SUNSET VILLAGE FILING 4 - DRAINAGE
EL PASO COUNTY, COLORADO

CONSTRUCTION DRAWINGS
POND 2

SUNSET VILLAGE
FILING NO. 4

OUTLET STRUCTURE DETAILS

JOB #21004166

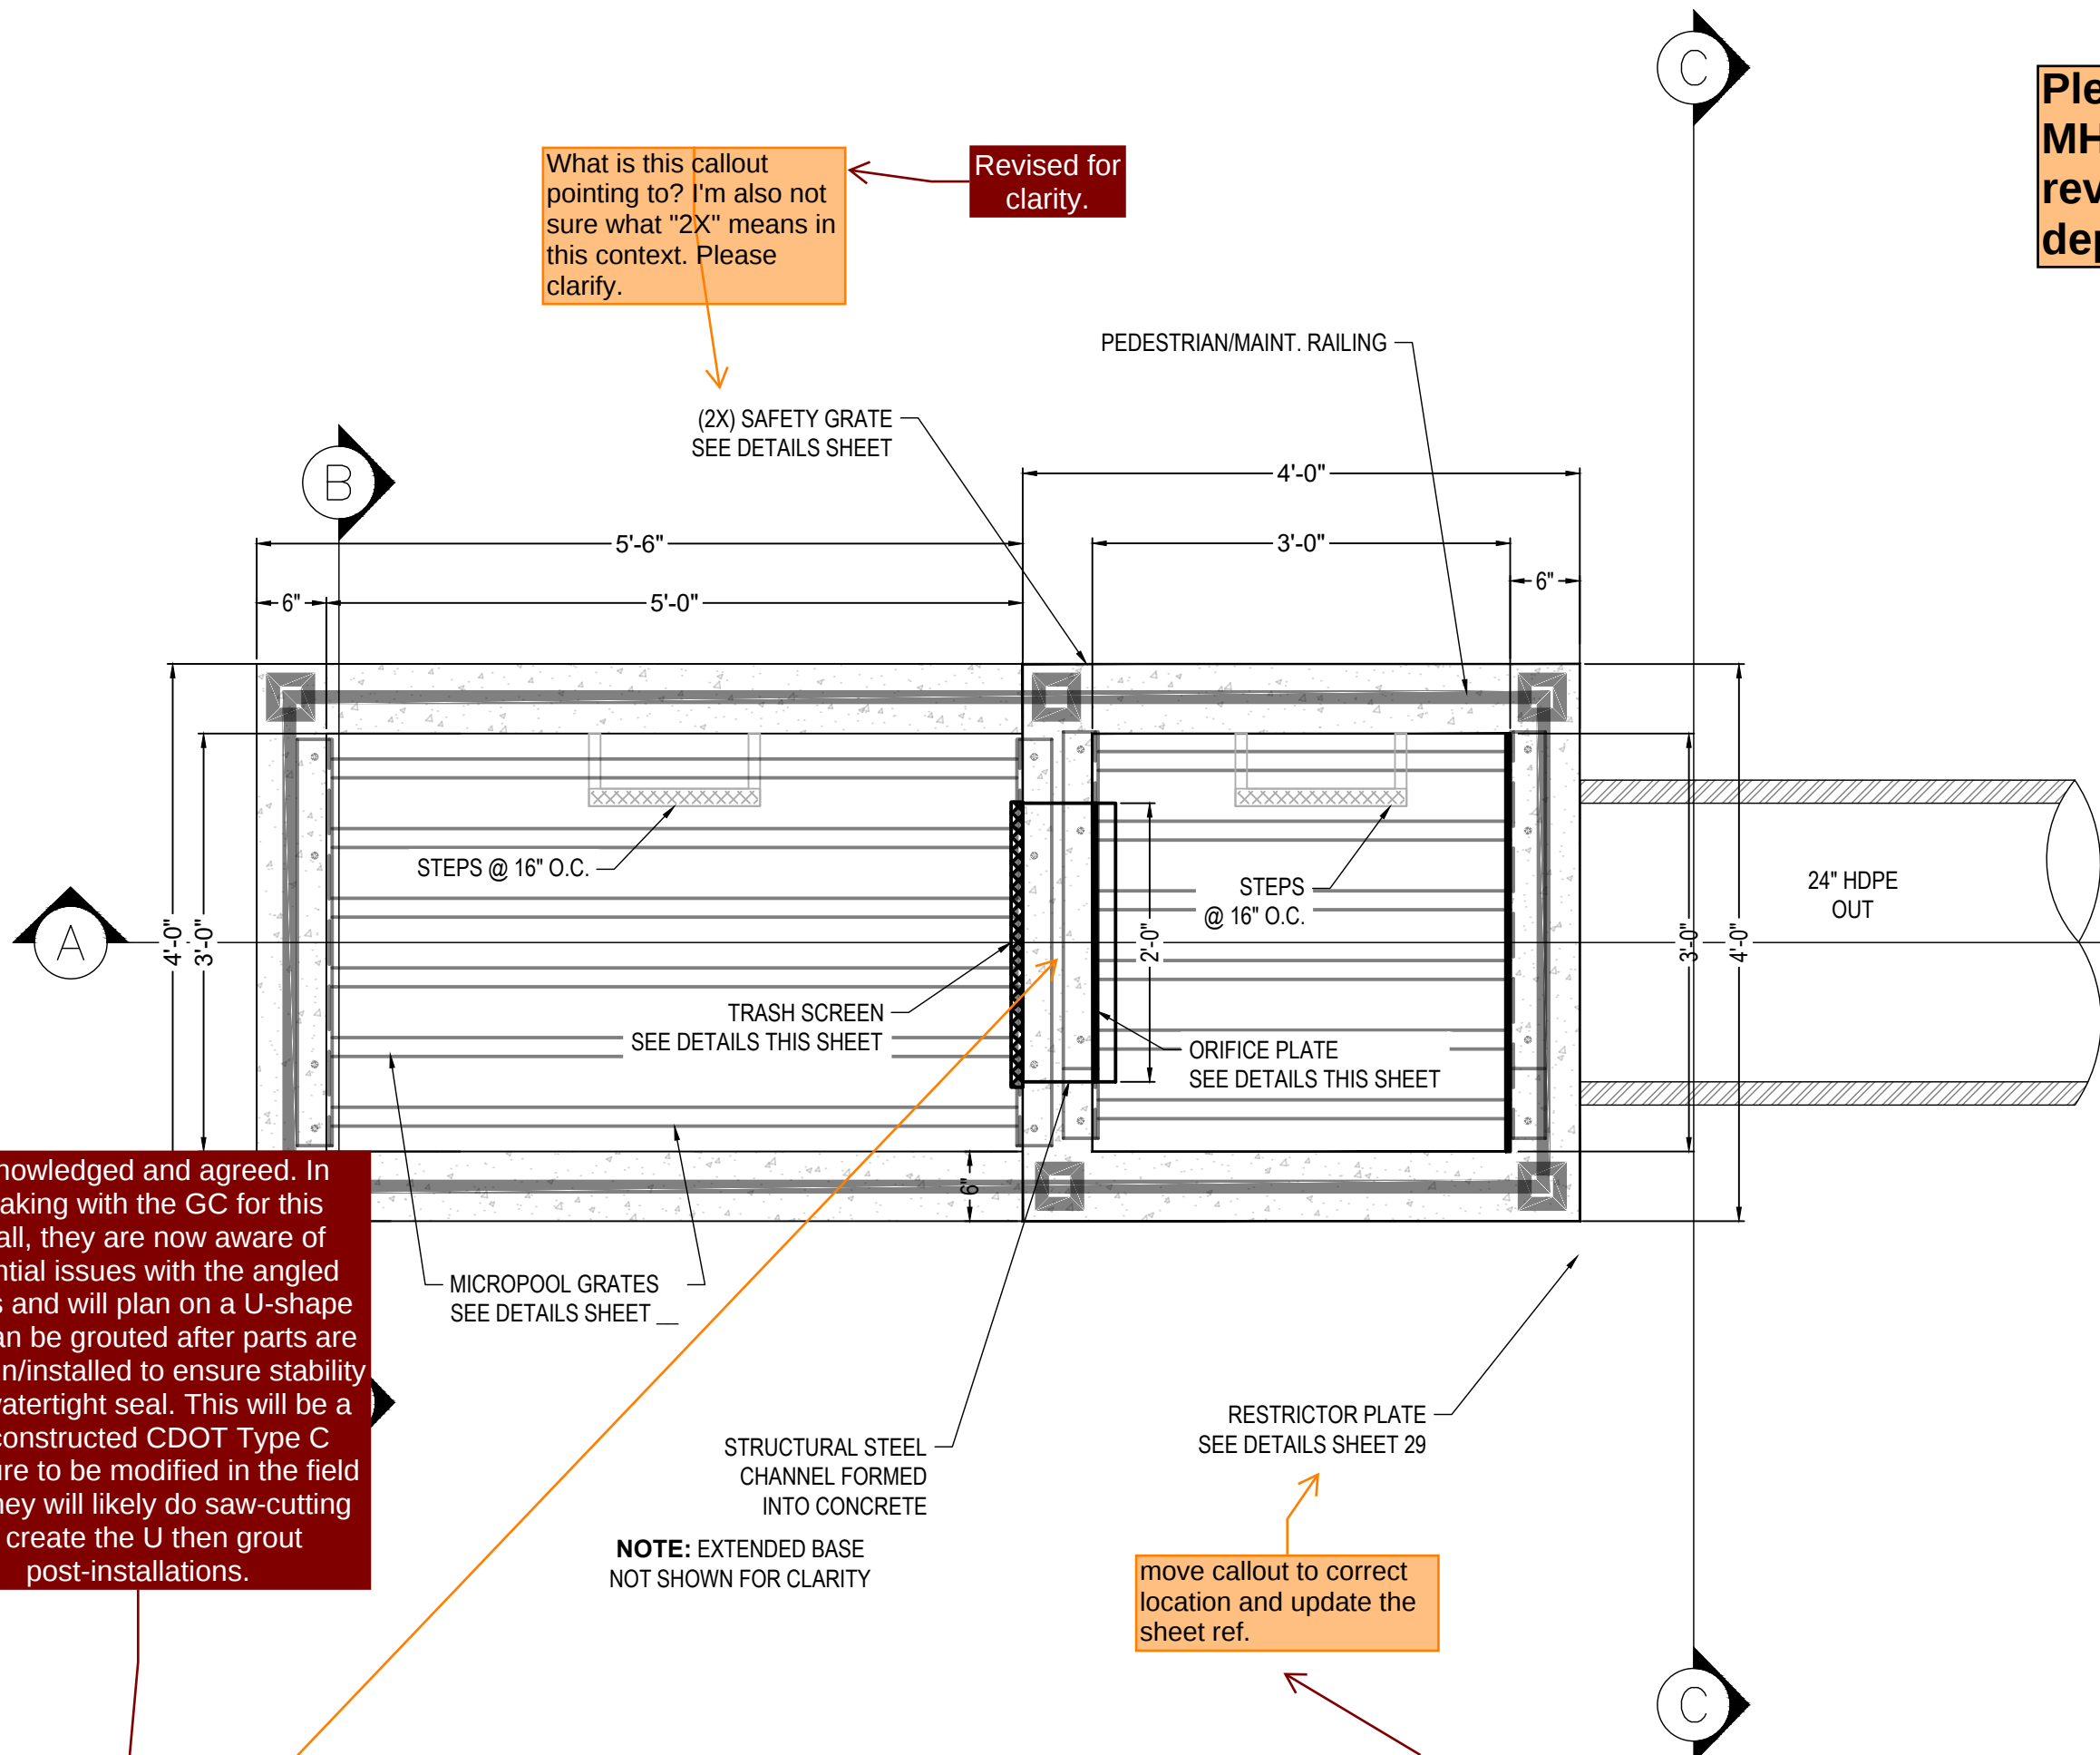
Please update the Pond 2 plan to be consistent with the revised pond outlet structure and forebay details shown on Sheets 20-22. Several elevations on the current Pond 2 sheet—including top of micropool, WQCV WSEL, EURV WSEL, and 100-year WSEL—do not match the updated design information.

Please note that ELX does not have access to previous CAD files from original approved CDR plans. Any revisions and changes required on this plan sheet are directly done via PDF, consistent with the revisions in the last CDR application for the subdivision.

ORIFICE PLATE NOTES:

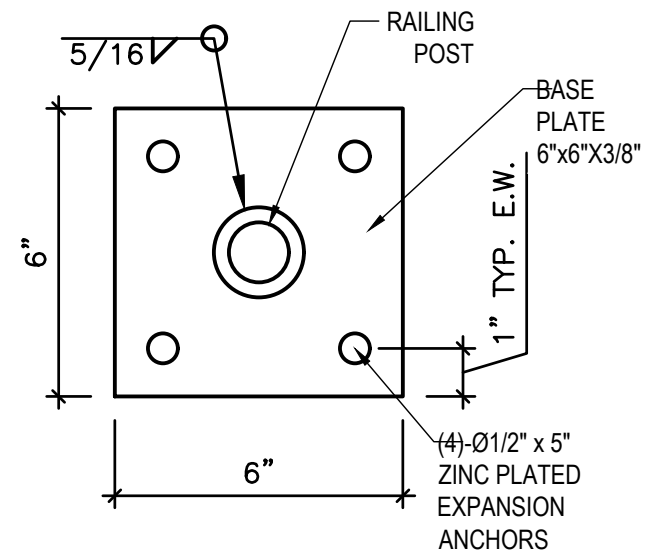
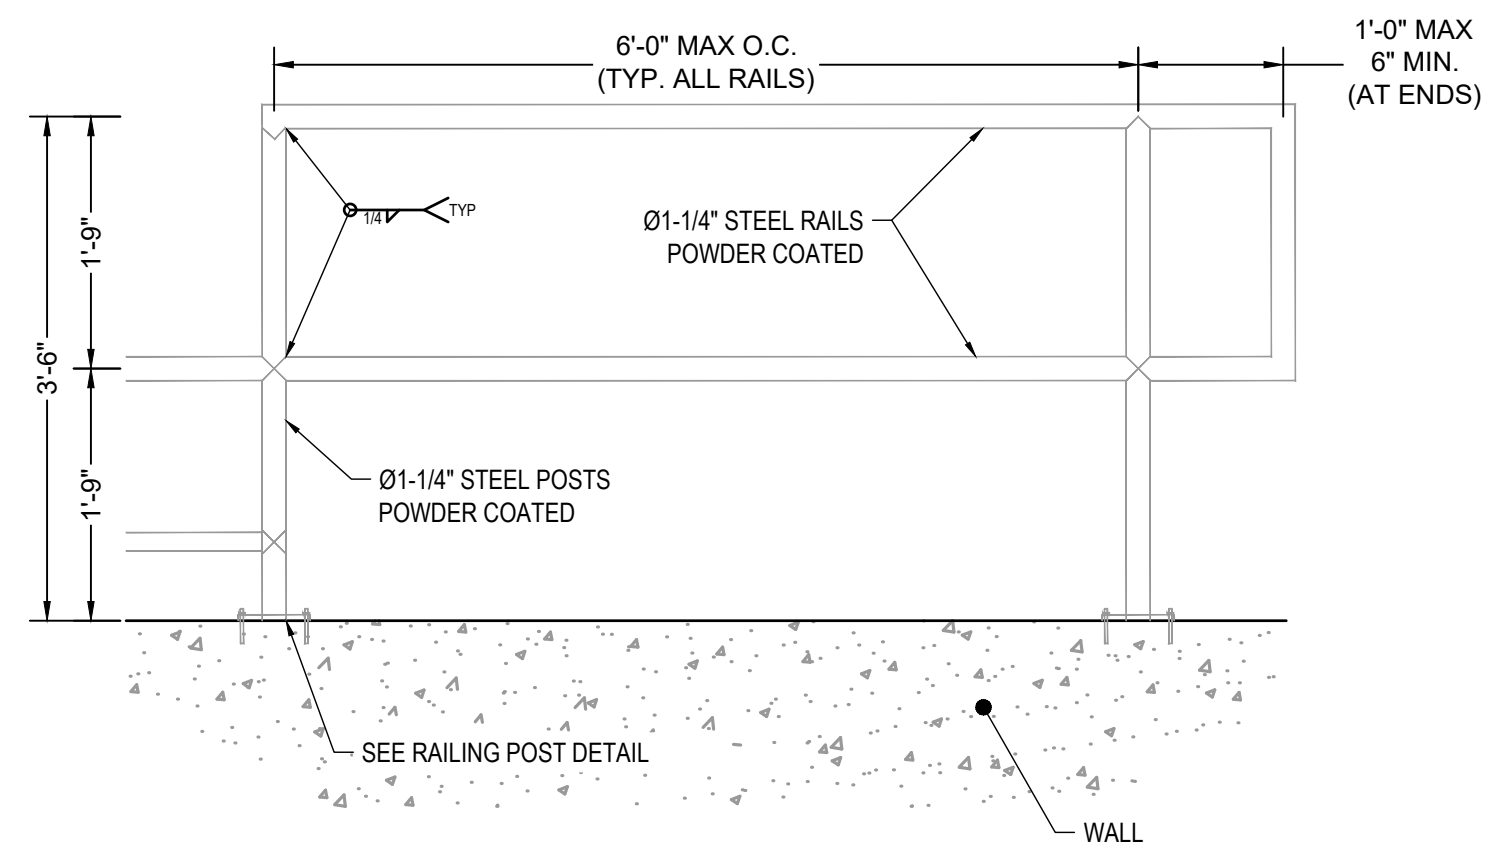
I think you can delete Note #3, since #5 below is a more detailed version of it.

Note #3 removed.

POND OUTLET STRUCTURE (ELEVATION VIEW, SECTION A-A) SCALE: 1" = 1-1/4'

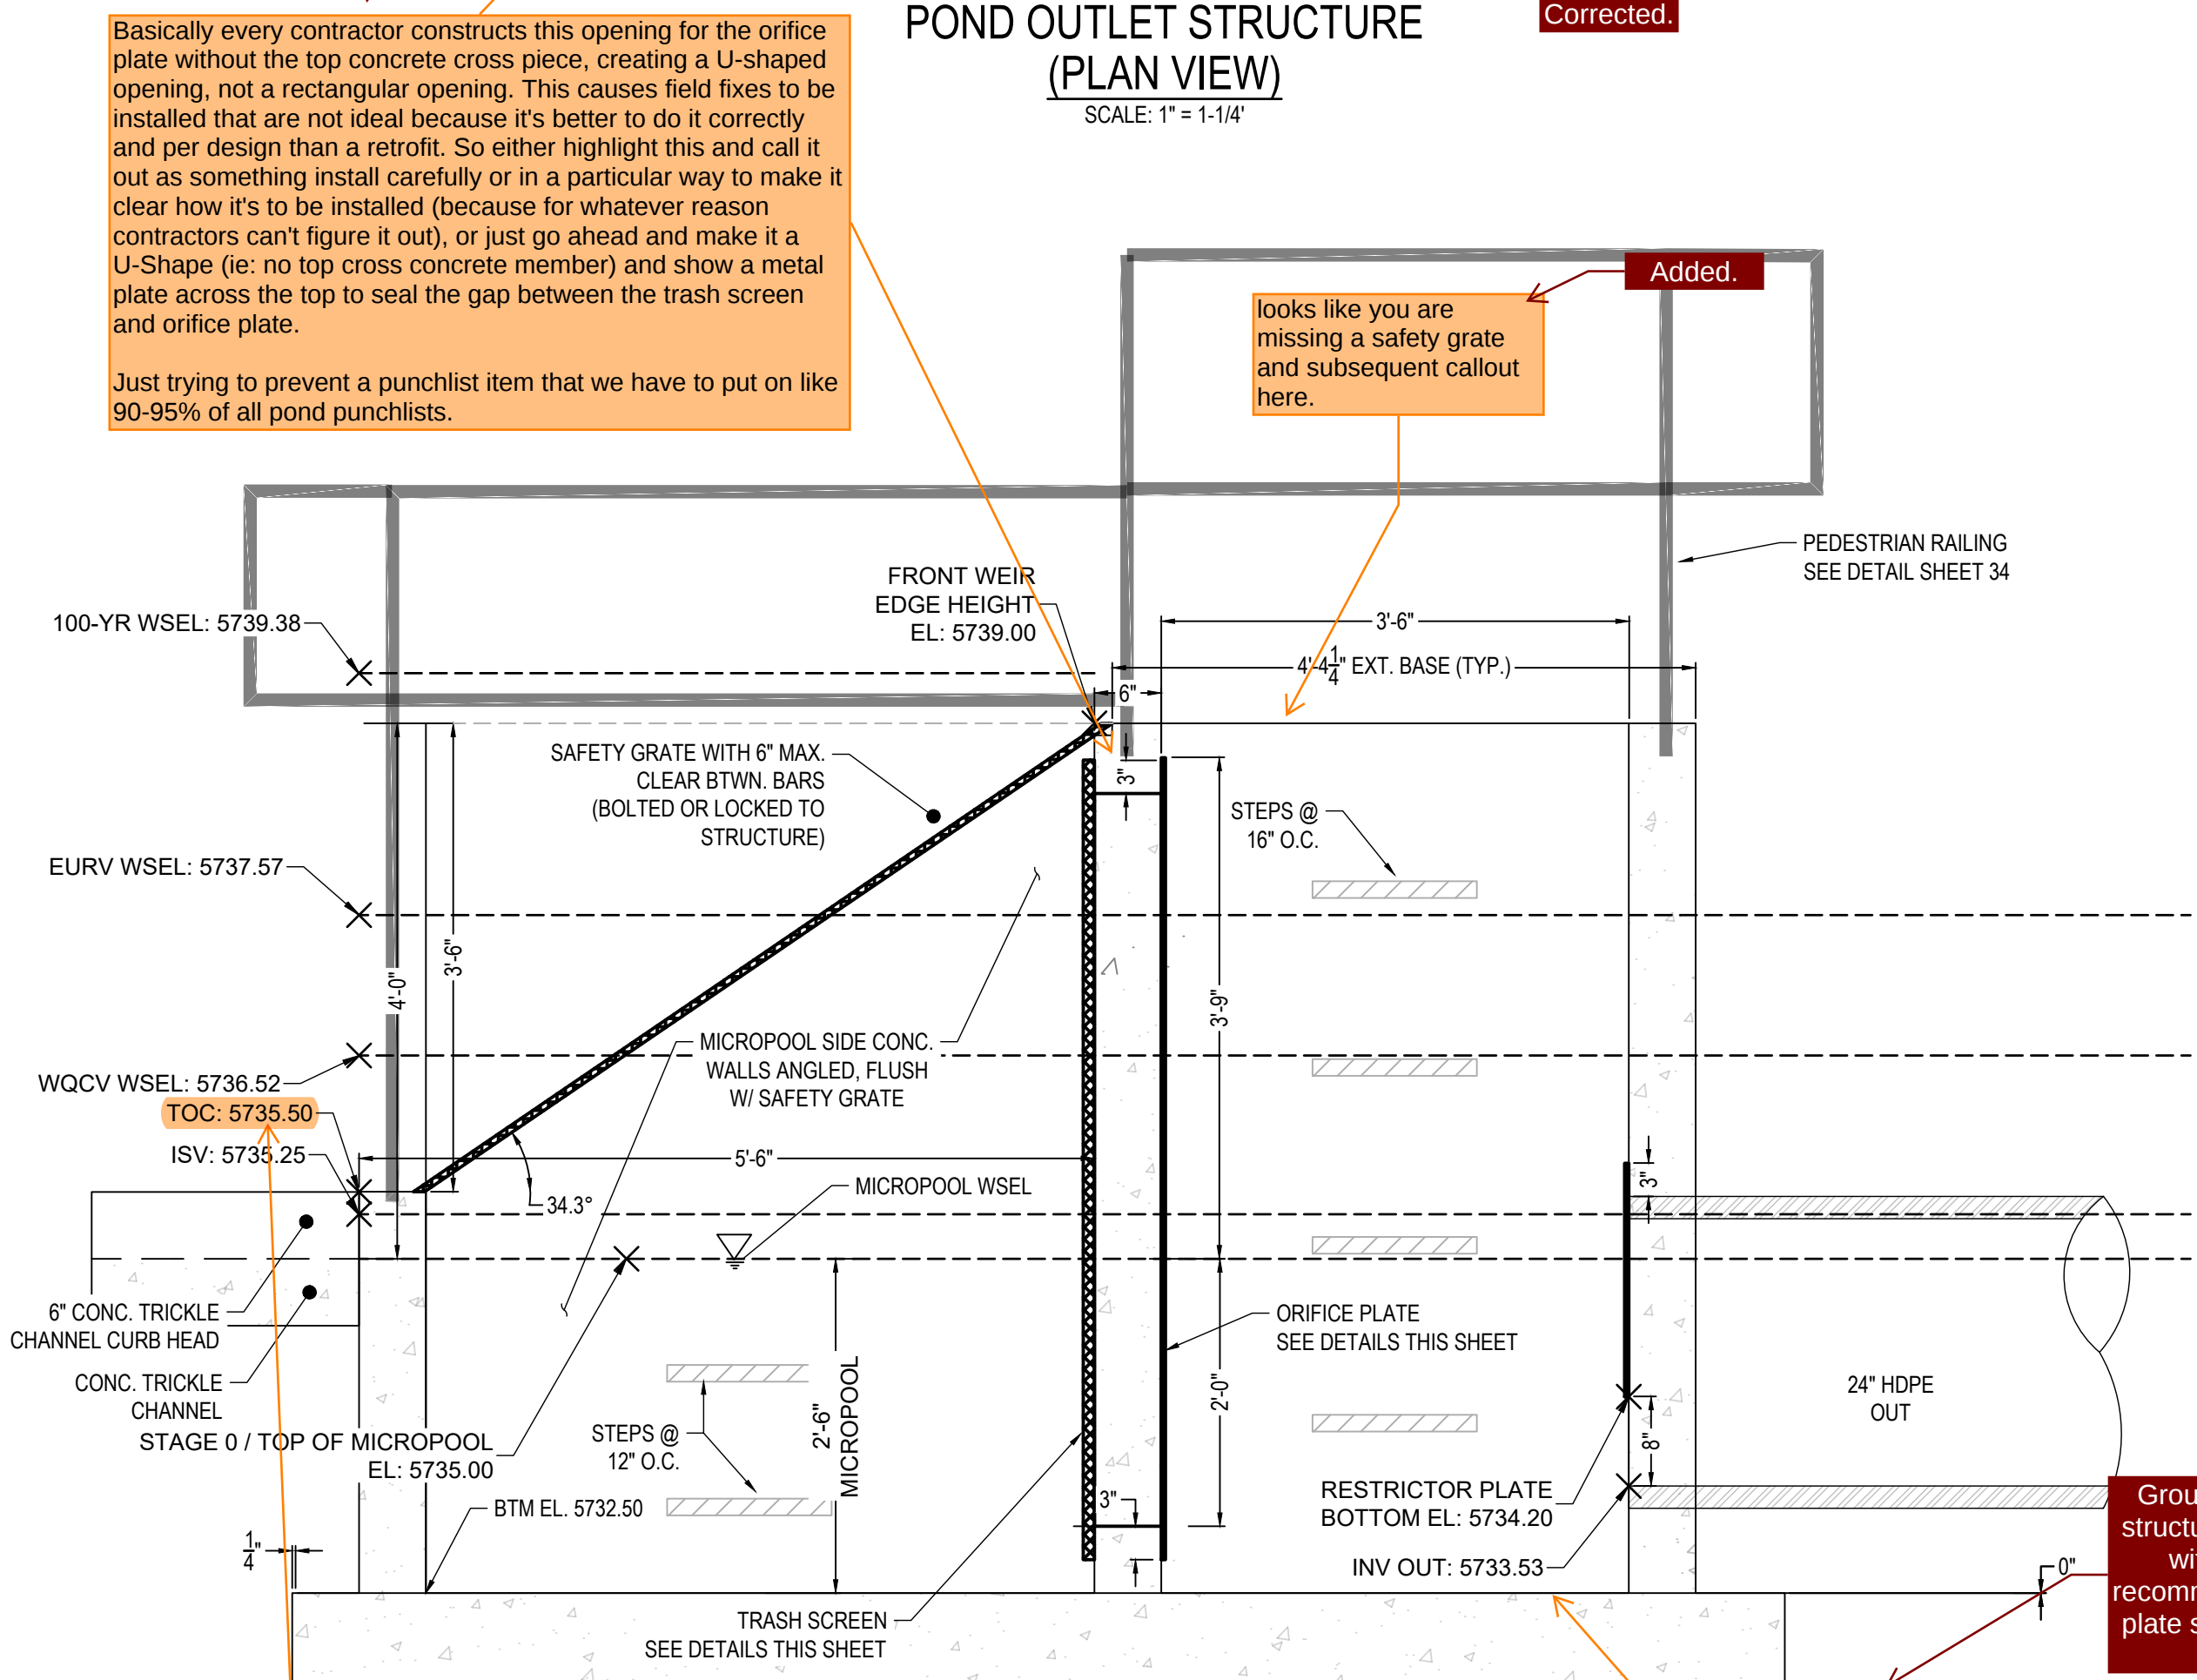
It's not ideal to have this area hold water. Recommend showing it filled with grout, angled towards the outlet pipe. Specifically: Per previous MHFD DCMv3 Detail T-12, the outlet structure bottom should have a shaped invert of 2.5% minimum slope.

Note: that obviously you don't want the grout to be placed up above the bottom of the orifice plate, so you may need to raise the orifice plate up (ie: make it shorter).

Per Laura's blue comment in the upper left corner of Sht 17 above, this is an example of one of the elevations that needs to be resolved. Compared to the plan on Sht 17, the top of the trickle channel will be 6" above the pond bottom, which is not acceptable.

Grouted bottom of structure now shown with slope as recommended. Orifice plate shortened from bottom.

Stage Zero to remain 35.00 to keep all infrastructure and elevations consistent with the design proposed. Now shown as invert of low-flow channel only, consistent with previously approved CDR plans.
